CATAWBA NUCLEAR STATION, UNIT 1

AMENDMENT TO FACILITY OPERATING LICENSE

Amendment No. 113
License No. NPF-35

Amendment No. 107
License No. NPF-52

Figure 2.1-1a
REACTOR CORE SAFETY LIMITS - FOUR LOOPS IN OPERATION
382,000 gpm

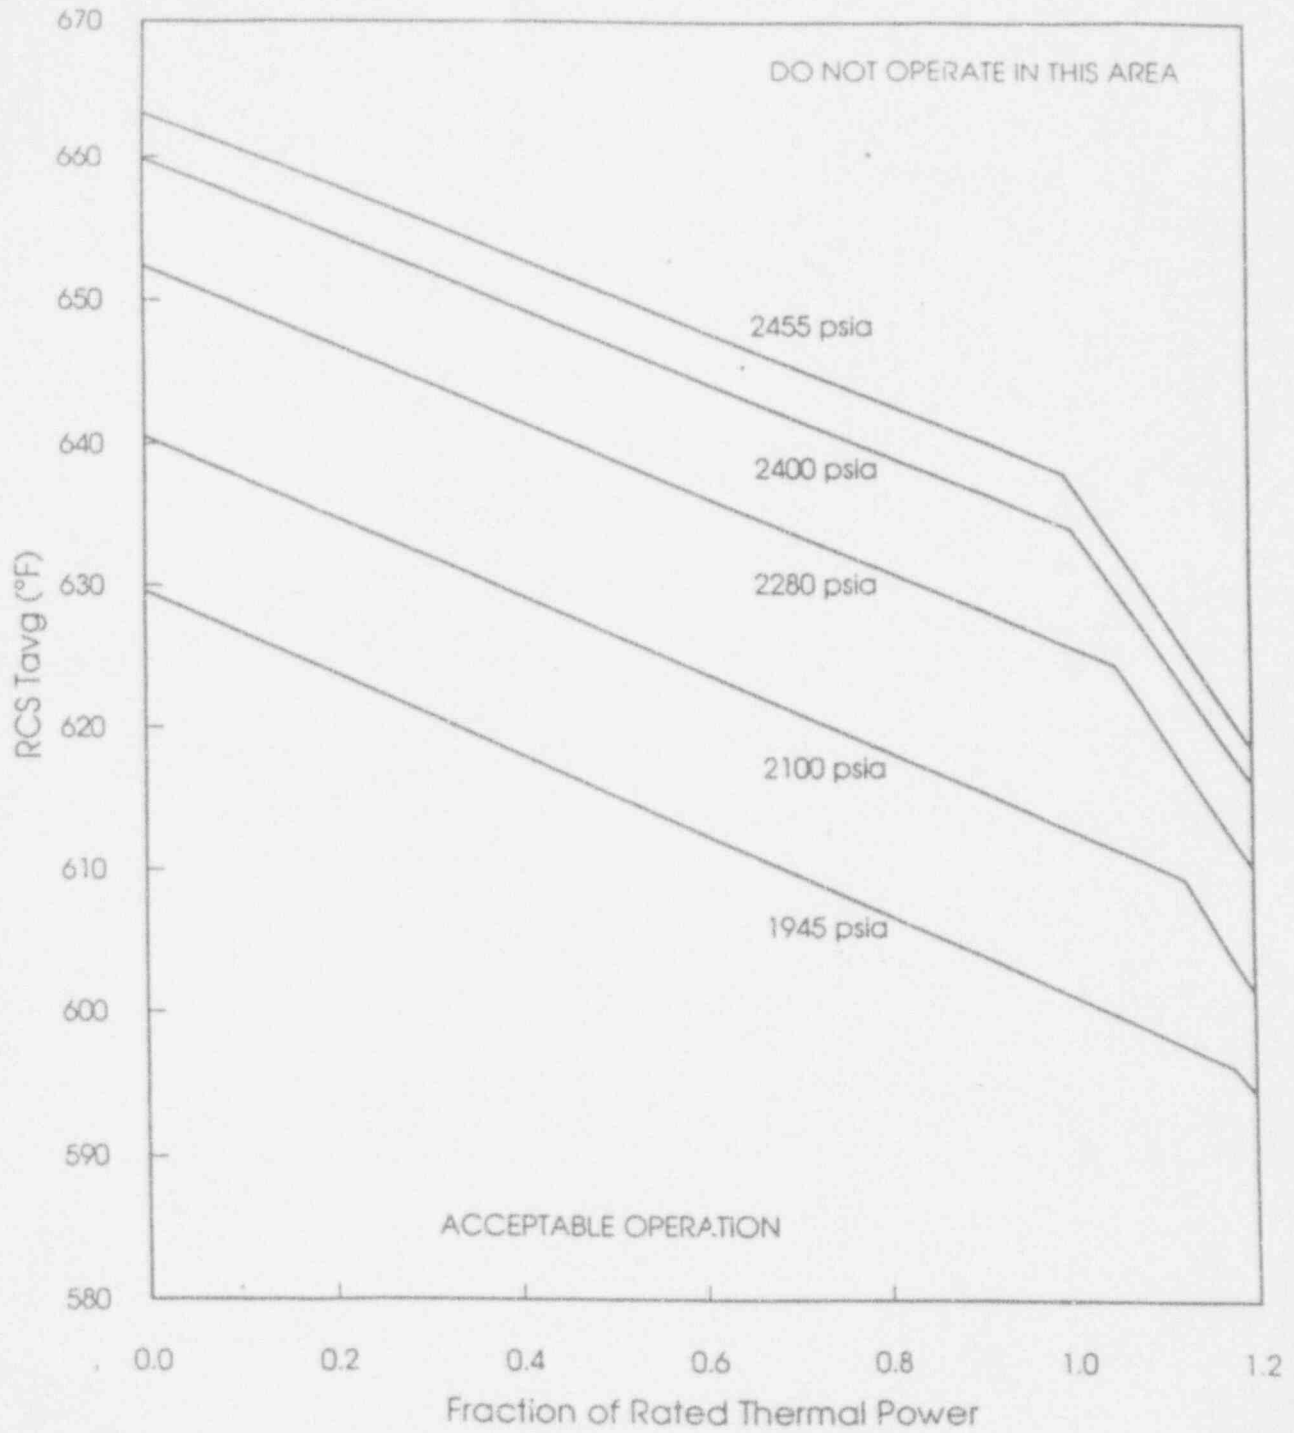
Replace the following pages of the Appendix "A" Technical Specifications with the enclosed pages. The revised pages are identified by Amendment number and contain vertical lines indicating the areas of change.
